Tiva™ C Series TM4C129x Microcontrollers Silicon Revisions 1, 2, and 3

This document describes known exceptions to the functional specifications for all of the Tiva™ C Series TM4C129x microcontrollers. Note that some features are not available on all devices in the series, so not all errata may apply to your device. See your device-specific data sheet for more details.

Figure 2. RC Circuit

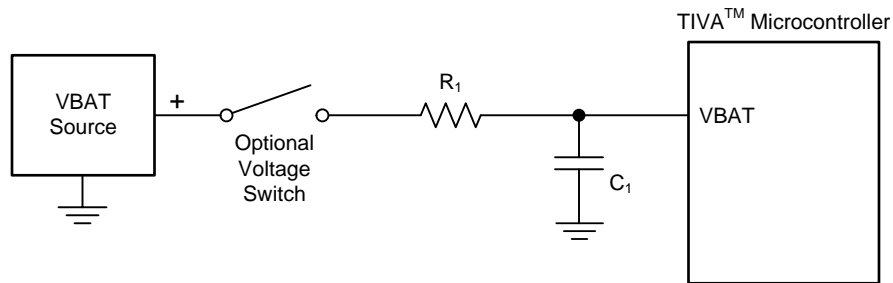
Description The V_{BAT} supply pin may be damaged if the pin voltage ramps faster than 0.7 V/μs. Fast V_{BAT} ramps are a concern when a battery is being connected or the V_{BAT} supply is hard switched.

Workaround(s) An RC circuit as shown should be added to the V_{BAT} pin to prevent the damage. The R₁ and C₁ should be placed close to the microcontroller for best protection. In systems that do not require Hibernate when the VDD supply is off, the V_{BAT} pin should be tied to the VDD supply, which typically ramps at a rate slower than 0.7 V/μs. The R1 and C1 components are not required for a V_{BAT} supply ramp less than 0.7 V/μs.

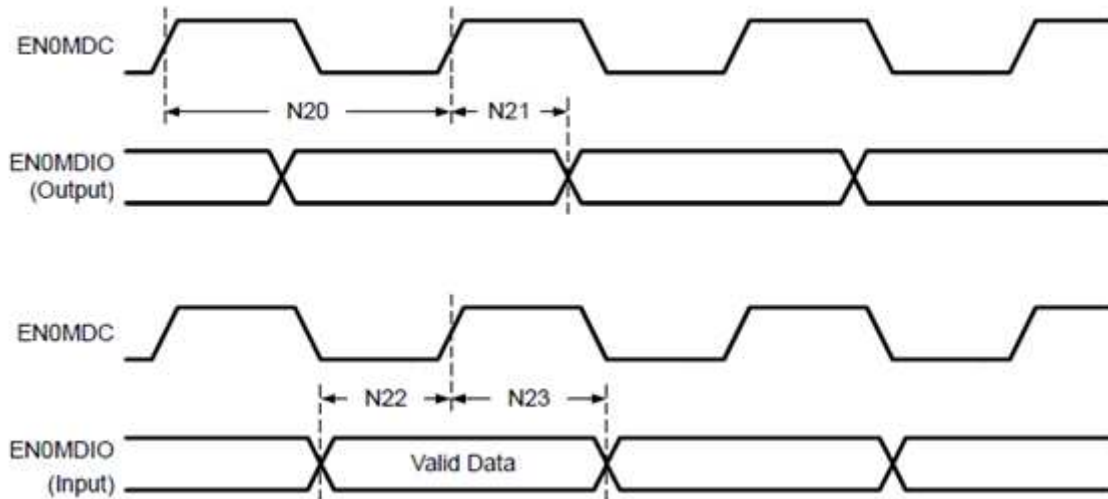
ETH#05 *SMI Electrical Section Update (2)*

Description: The following timing diagram in the Electrical Characteristics for Ethernet Controller AC Characteristics for MII Serial Management is the corrected diagram.

Figure 3. VDDA Waveform to Avoid Between V_{POR} min and V_{POR} max

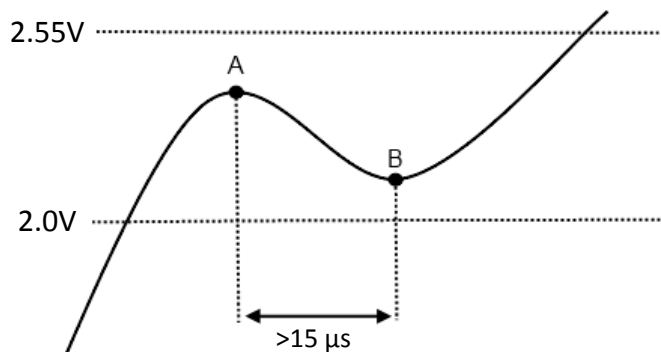
Workaround(s): A monotonic voltage rise of VDDA prevents this issue from occurring; however, a perfect monotonic ramp is difficult to achieve, particularly during LDO inrush. The risk of encountering this issue can be minimized by performing one of the following:

- If the VDD and VDDA pins are connected directly to the same power source, at every possible point A and point B along the VDDA waveform between 2.0 V and 2.55 V, point B must never fall below point A after 15 μ s, as shown in [Figure 3](#).
- Use a separate power supply for VDDA to reduce noise and isolate it from the effects of LDO inrush. At every possible point A and point B along the VDDA waveform between 2.0 V and 2.55 V, point B must never fall below point A after 15 μ s, as shown in [Figure 3](#). The separate power supply will make it easier to avoid this condition.
